**DOCUMENT 00 90 00
ADDENDUM**

ADDENDUM NO. [1] Date: February 17, 2020

**RE: WESTERN TECHNICAL COLLEGE
 APPRENTICESHIP CENTER REMODEL
 2860 21ST PLACE SOUTH
 LA CROSSE, WISCONSIN 54601
 HSR PROJECT NO. 19021**

This Addendum consists of [2] page, [1] specification sections and [9] 30 x 42 drawings.

1 ENLARGED ELECTRICAL ROOM 120 AND ELECTRICAL COMMERCIAL LAB PLANS
E202 SCALE: 1/2" = 1'-0"

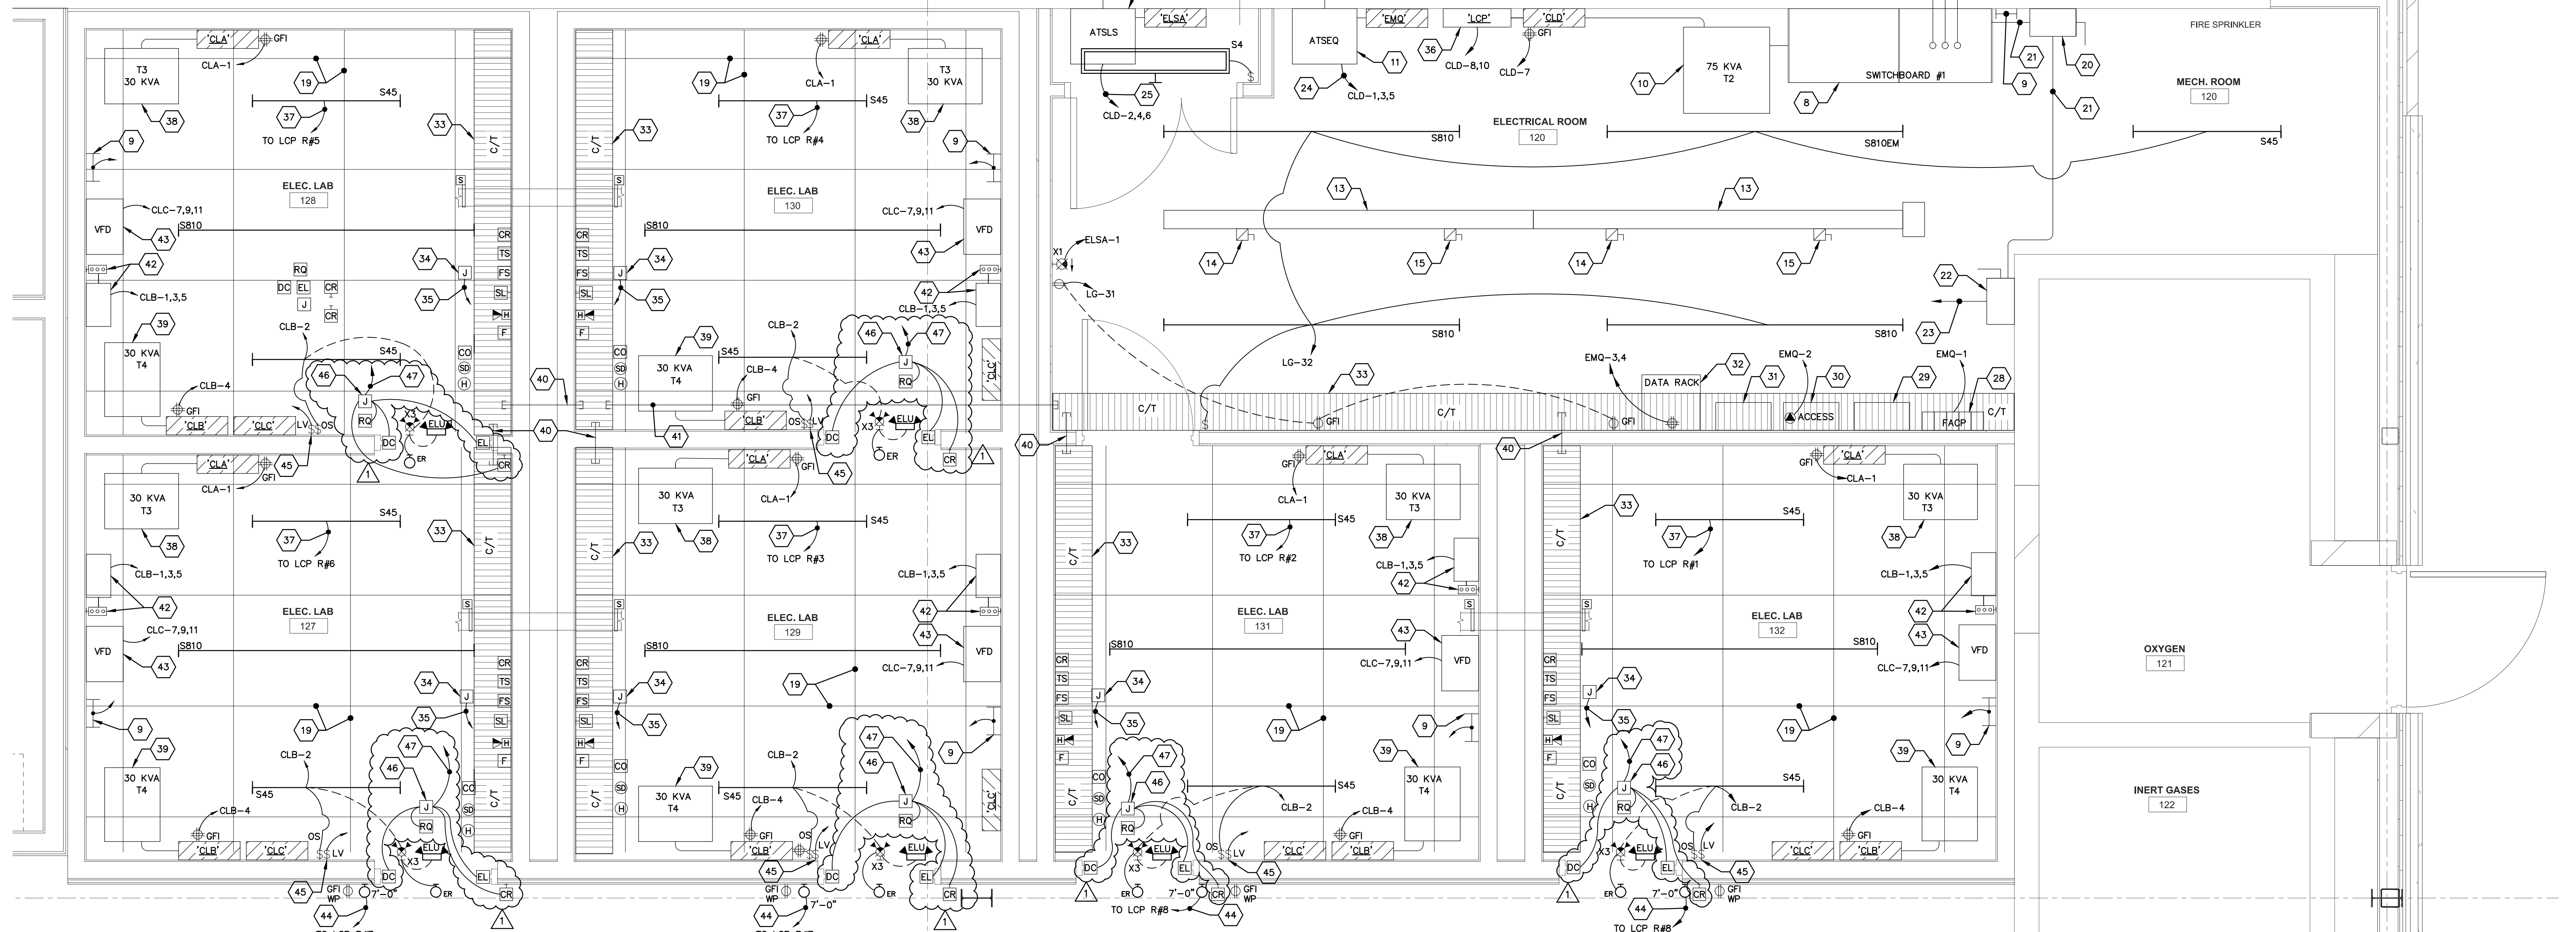
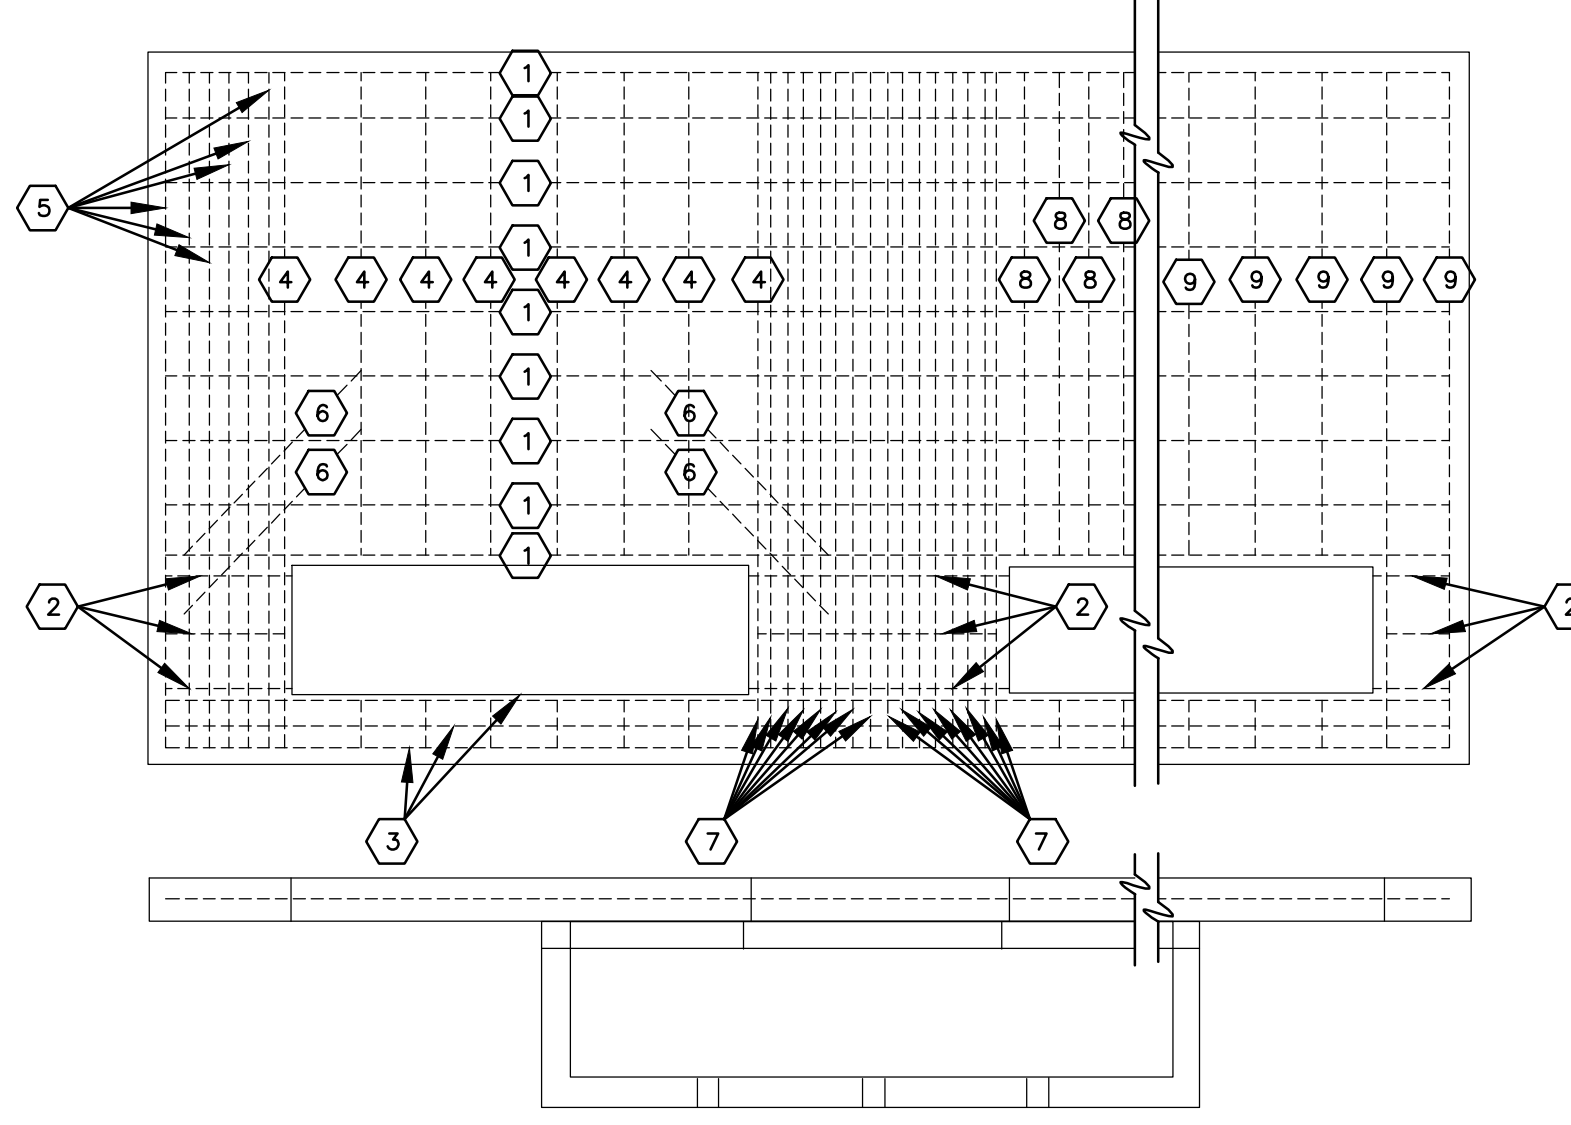
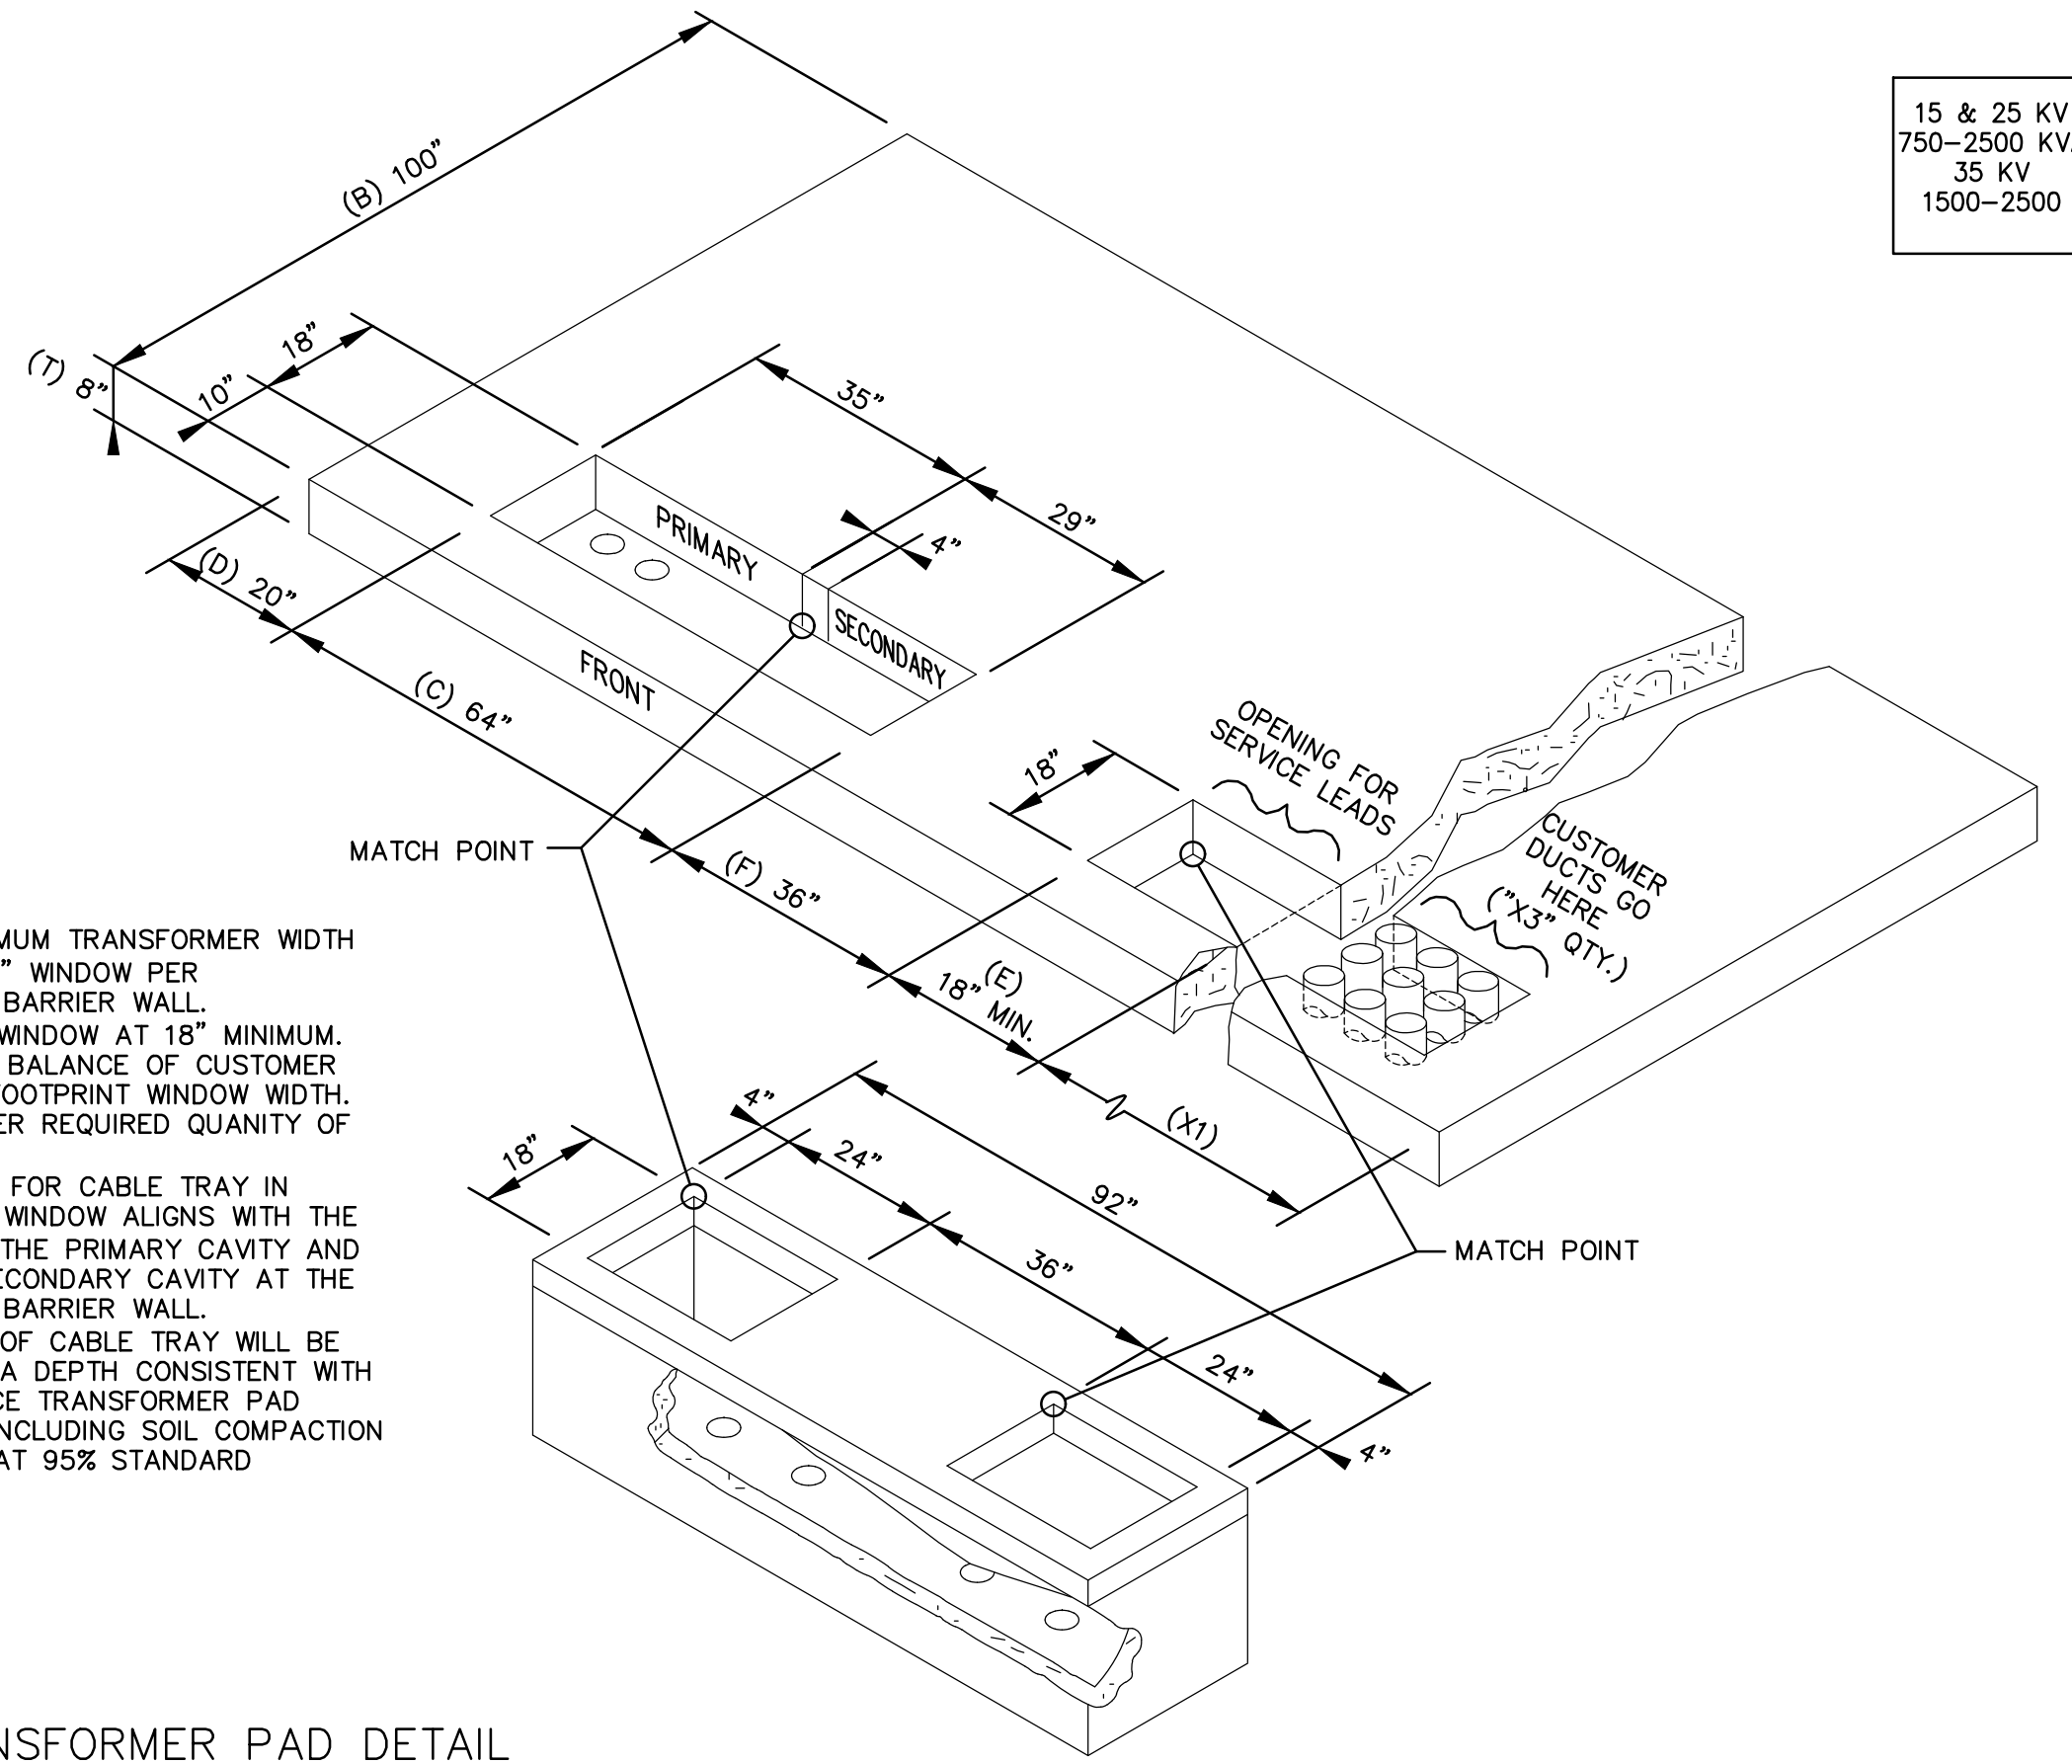
- a. Revisions clouded on Drawing.
12. Sheet E202R ENGLARGED POWER PLAN 30 x 42 attached hereto
 - a. Revisions clouded on Drawing.
